APPLICATION NO.	FILING DATE	FIRST NAMED INVENTOR	ATTORNEY DOCKET NO.	CONFIRMATION NO.
10/618,521	07/11/2003	Thomas F. Calton	40682/298	5072
32642 STOEL RIVES	7590 03/19/200 LLP - SLC	EXAMINER		
201 SOUTH MAIN STREET, SUITE 1100			SWIGER III, JAMES L	
ONE UTAH CENTER SALT LAKE CITY, UT 84111			ART UNIT	PAPER NUMBER
			3775	
			MAIL DATE	DELIVERY MODE
			03/19/2009	PAPER

Application No.	Applicant(s)				
	10/618,521	CALTON ET AL.				
Office Action Summary	Examiner	Art Unit				
	JAMES L. SWIGER	3775				
The MAILING DATE of this communication appears on the cover sheet with the correspondence address Period for Reply						
A SHORTENED STATUTORY PERIOD FOR REPLY IS SET TO EXPIRE 3 MONTH(S) OR THIRTY (30) DAYS, WHICHEVER IS LONGER, FROM THE MAILING DATE OF THIS COMMUNICATION.  - Extensions of time may be available under the provisions of 37 CFR 1.136(a). In no event, however, may a reply be timely filed after SIX (6) MONTHS from the mailing date of this communication.  - If NO period for reply is specified above, the maximum statutory period will apply and will expire SIX (6) MONTHS from the mailing date of this communication.  - Failure to reply within the set or extended period for rep

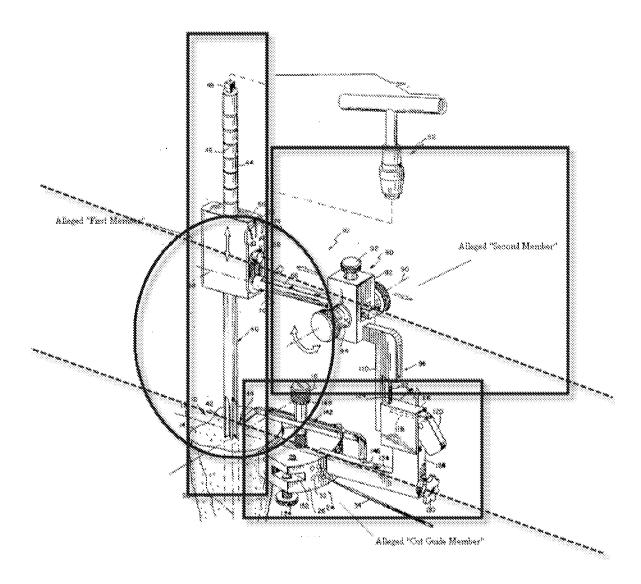
Claims 1-3, 4-6, 11, 25-26, 29, 32, 34, 35-37 are rejected under 35 U.S.C. 102(b) as being anticipated by Bowman et al. (US Patent 4,952,213). Bowman et al. ("Bowman") disclose an orthopedic cutting guide device (see entire Fig. 1, and see annotated drawing below) comprising a first member (entire section on left which has a pivot axis extending along the length defined by the body of the first member, extending from 48 to approx bottom at 42), a second member (L-shaped section extending to the right and down), a cut guide (24) releasably secured directly to the second member, and wherein the first member is positioned between a cut guide and the second member (to further clarify, two dotted lines have been drawn to denote exemplary bounds of a cut guide portion and a second member; the oval area represents what portion of the first member is positioned between the cut guide member and the second member), and further wherein the cut guide and second member are able to move together and pivot about the axis of the first member (see arrows 70, this can be a pivot of a first member which the 2<sup>nd</sup> member and cut guides can move together around). As the cut guide is adjustable, the second member may be selectively released from the first member. The cut guide member is also capable of independent movement from the second member, as they are adjustable with respect to one another and the first member. It is also noted

that the device is configured to be selectively adjusted in both a rotational and translational manner while at least a portion of the device is anchored. Note the arrows in the device denoting various types of movement. See drawing below.

Bowman further discloses an orthopedic cutting guide device that has at least one securing member (34) and a boom (142) that fits into an opening of the cutting guide (Fig. 1, inserted into top opening). The cutting guide also has various surfaces to assist in guiding a tool, the first member has various surfaces such as a first and second side, also has a tapering(ed) portion (42) which extends from a point on the first member. The cutting guide portions also have various holes.
